ADDENDUM NO. 04

Project: **NEW TRANSPORTATION, MAINTENANCE and AGRICULTURAL BUILDINGS**
Channelview Independent School District

Bay Project No.: **0937**

C3.04R1

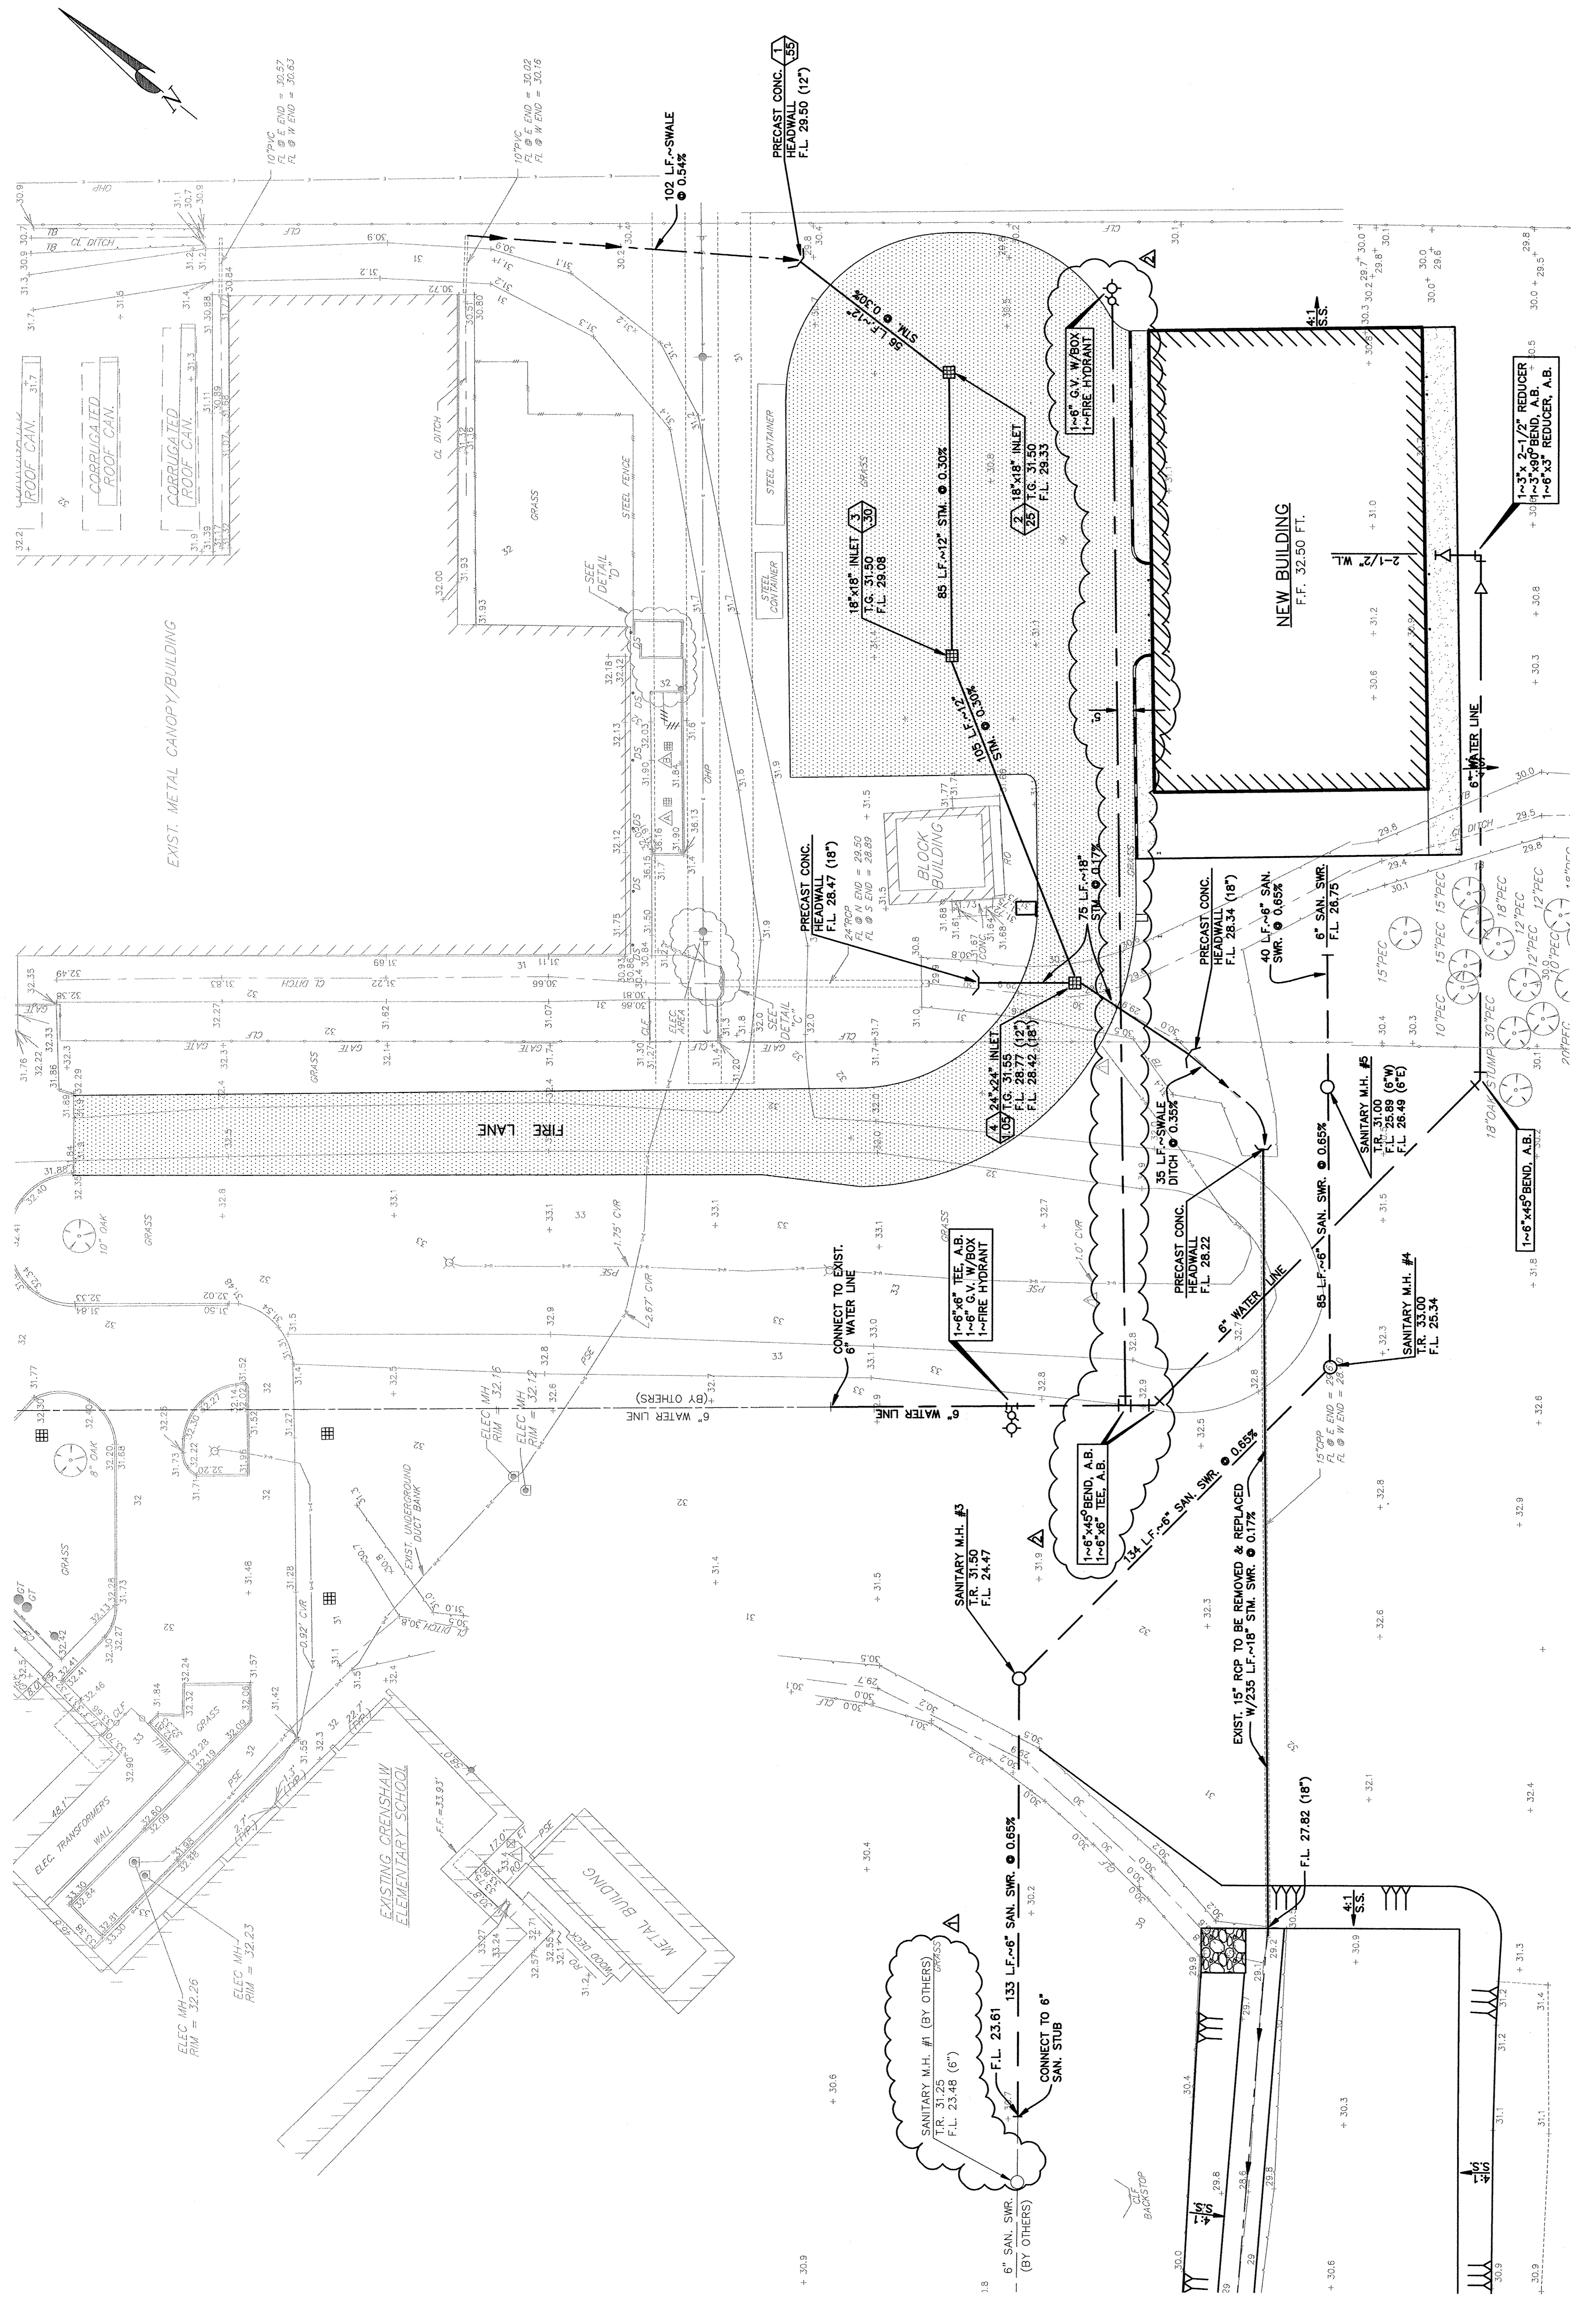
7. Sheet C2.04R1 Sanitary Sewer and Water Layout: Added two 2 inch reduced pressure backflow preventers at the new meter locations.
8. Sheet C2.04R1 Sanitary Sewer and Water Layout: Added external drop structures at the two sanitary sewer manhole connections.
9. Sheet C2.04R1 Sanitary Sewer and Water Layout: Changed the sanitary sewer from 4 inch to 6 inch at the New Transportation Building.
10. Sheet 3.04R1 Storm Sewer, Sanitary Sewer and Water Layout: Added a 6 inch water line and fire hydrant at the New Ag Building.
